CITY OF ALBUQUERQUE

October 19, 2017

RE: **Lot 1 Block 2 Unser Cliffs, S.A.D. 227**
6600 Rim Rock NW
Grading and Drainage Plan
Engineers Stamp Date 10-12-17 (D10D011)
Pad Certification Dated 10/12/17

CITY OF ALBUQUERQUE, BERNALILLO COUNTY		NEW MEXICO			
LOT 1, BLOCK 2 UNSER CLIFFS SUBDIVISION					
LANG -- MONDAY -- GRADING & DRAINAGE PLAN					
McDowell Engineering, Inc. 7820 BEVERLY HILLS AVE. NE • ALBUQUERQUE, NM 87122 TELE: 505-828-2430 • FAX: 505-821-4857					
Designed JSM	Drawn STAFF	Checked JSM	Sheet of		
File LANO217L	Date OCTOBER,2017	1	1

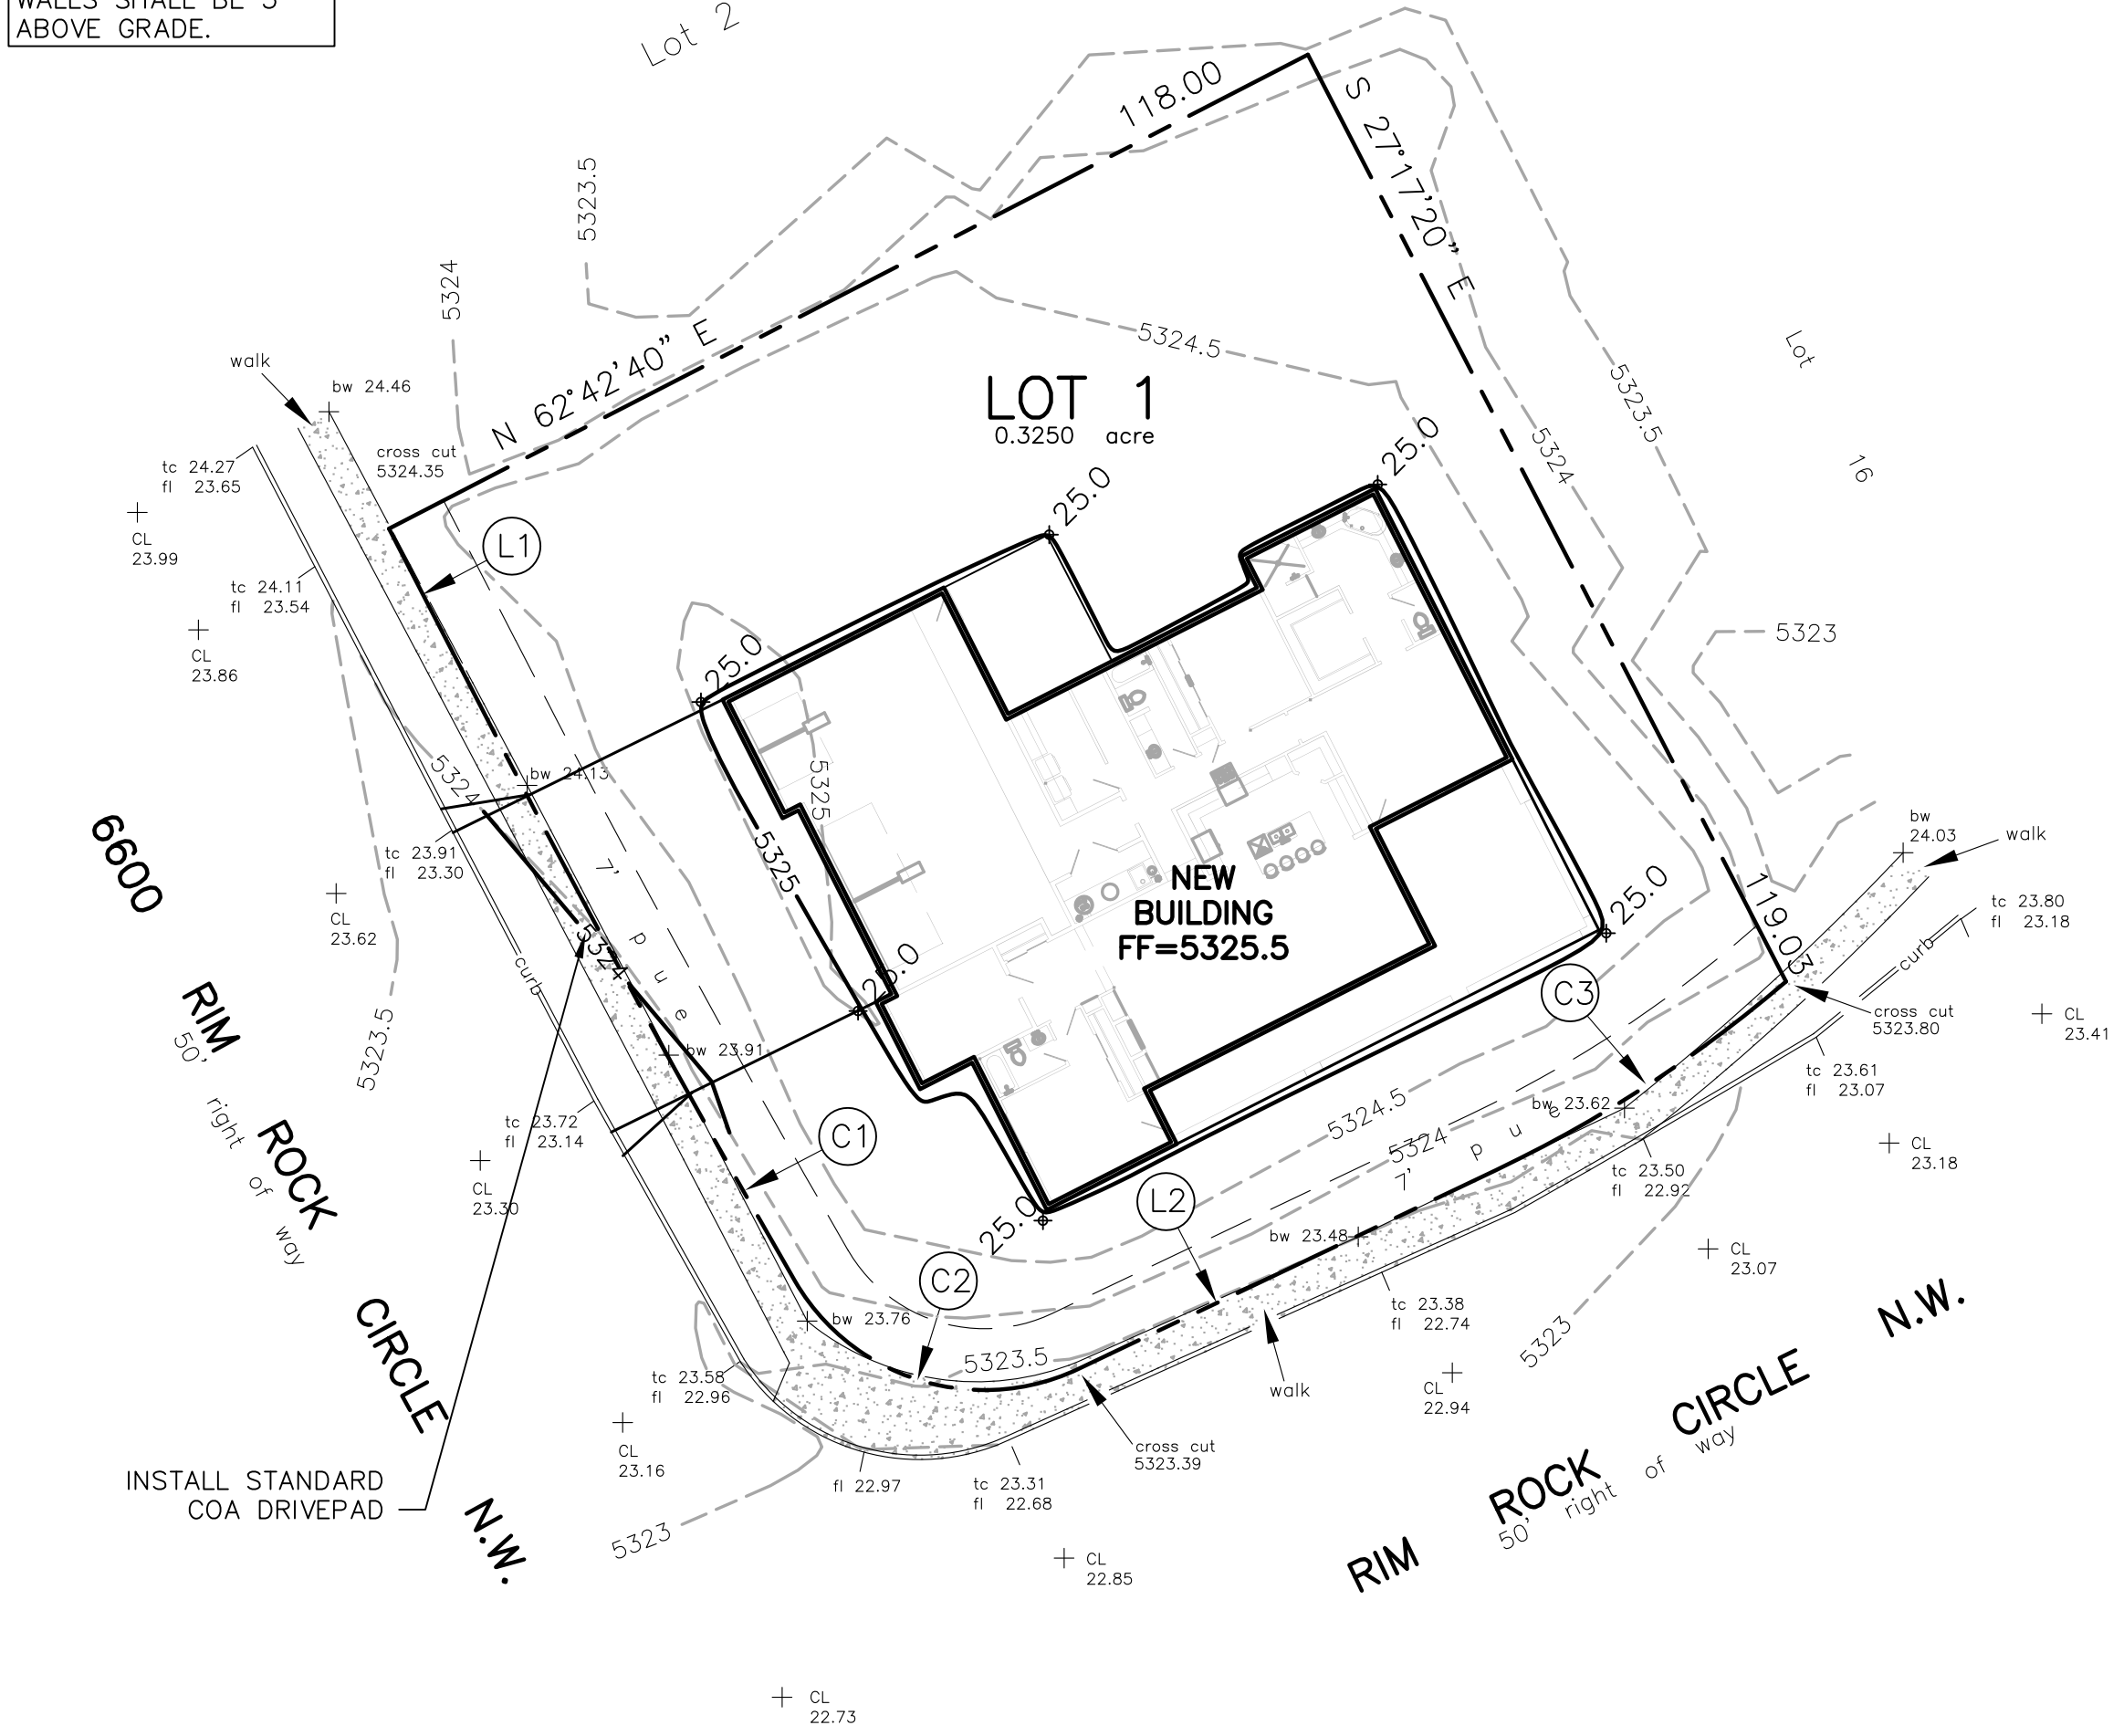
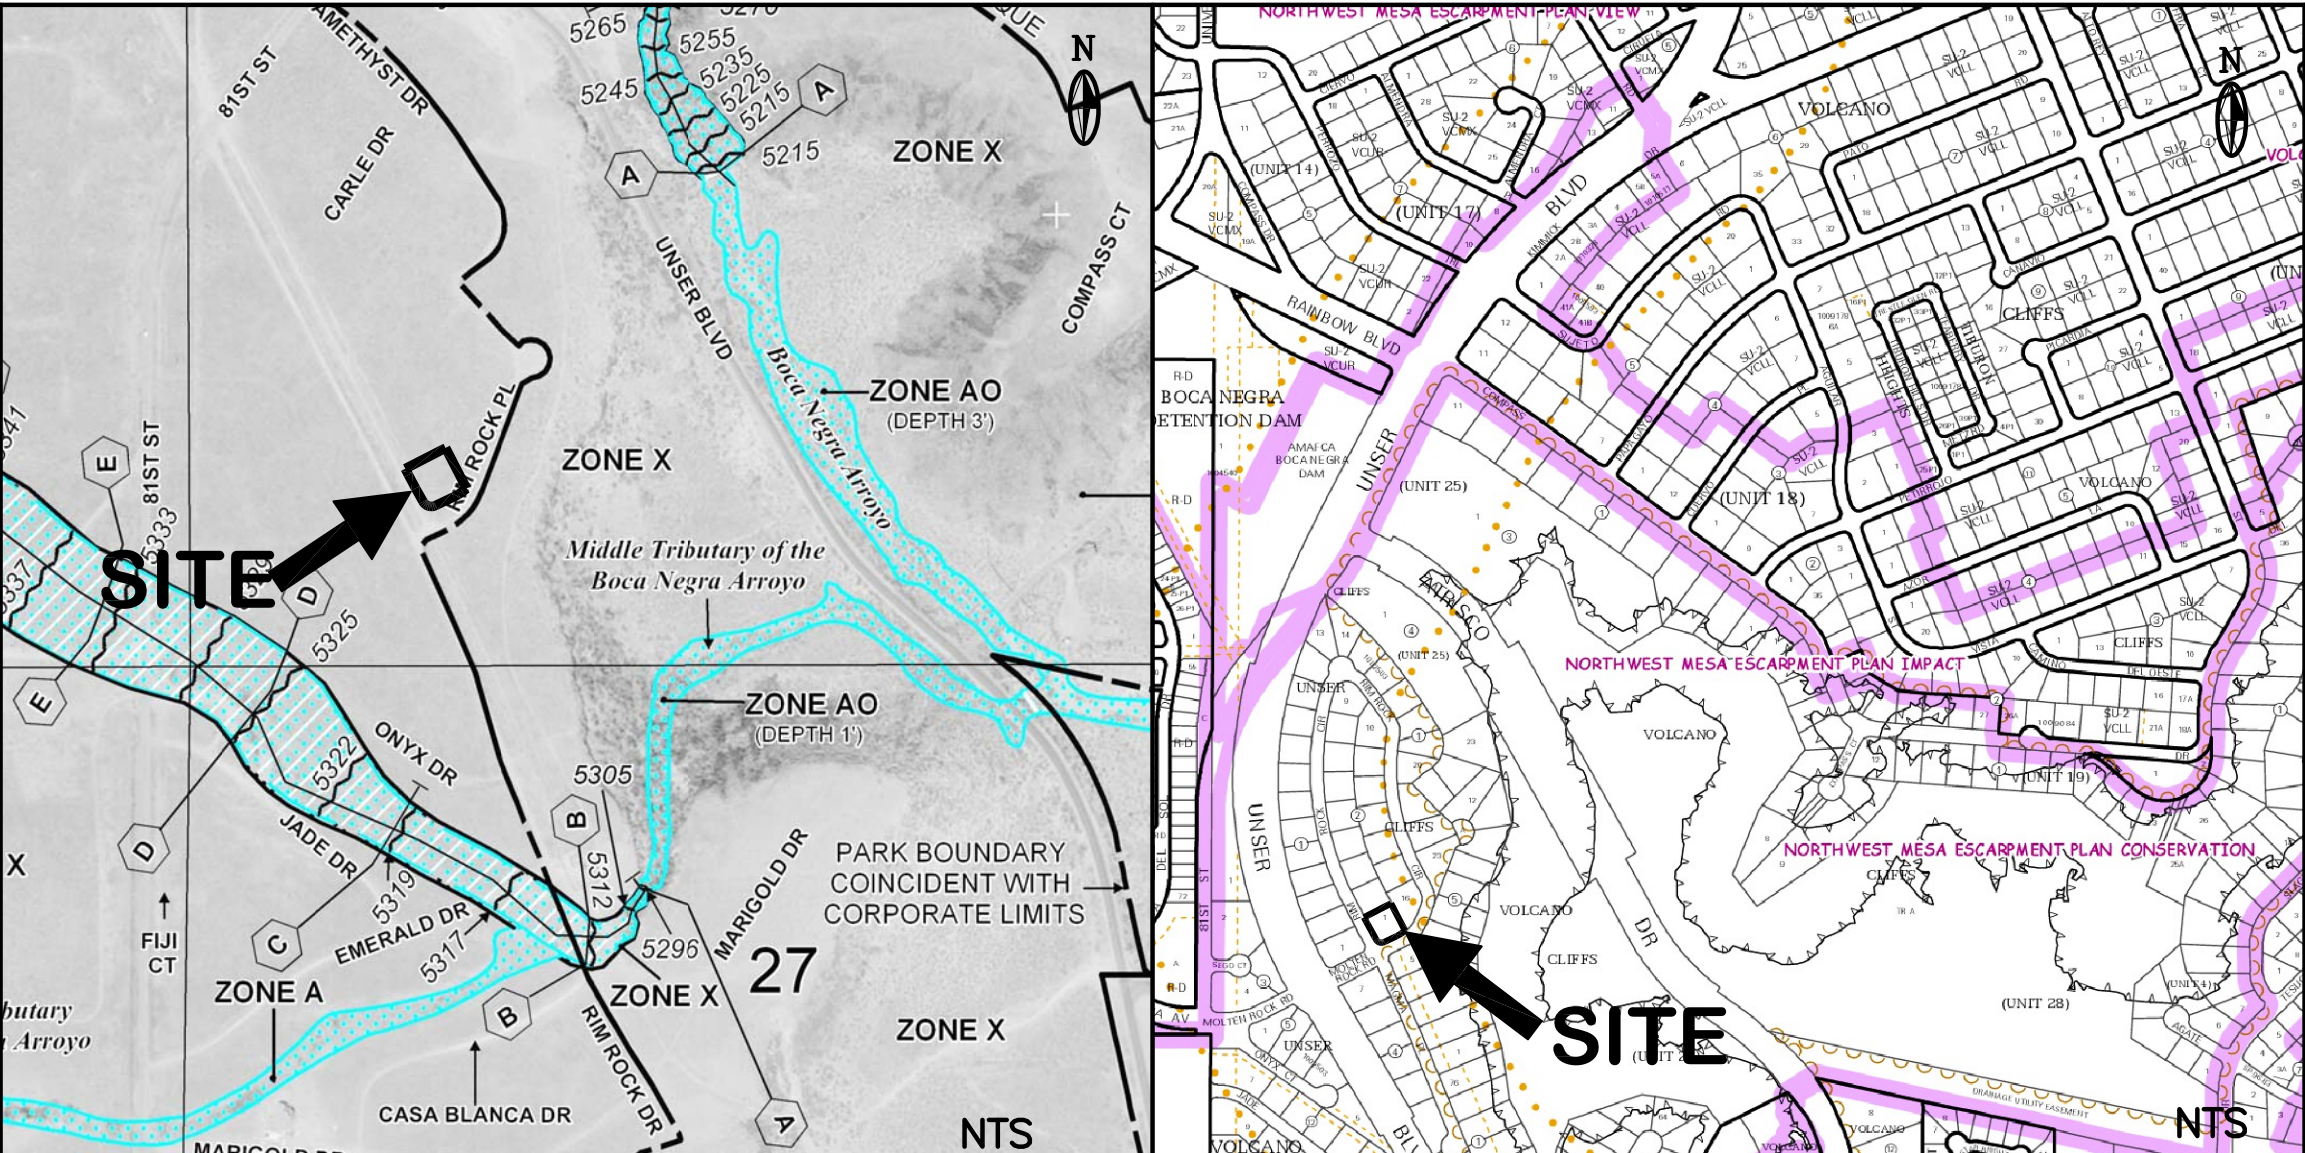
Based upon the information provided in your submittal received 10/16/17, this plan is approved for Building Permit.

Reiterate to the Owner/Contractor that a separate permit for a garden/retaining wall must be obtained, with the approved G&D plan dated 10/12/17.

Prior to Certificate of Occupancy release, Engineer Certification per the DPM checklist of this plan will be required.
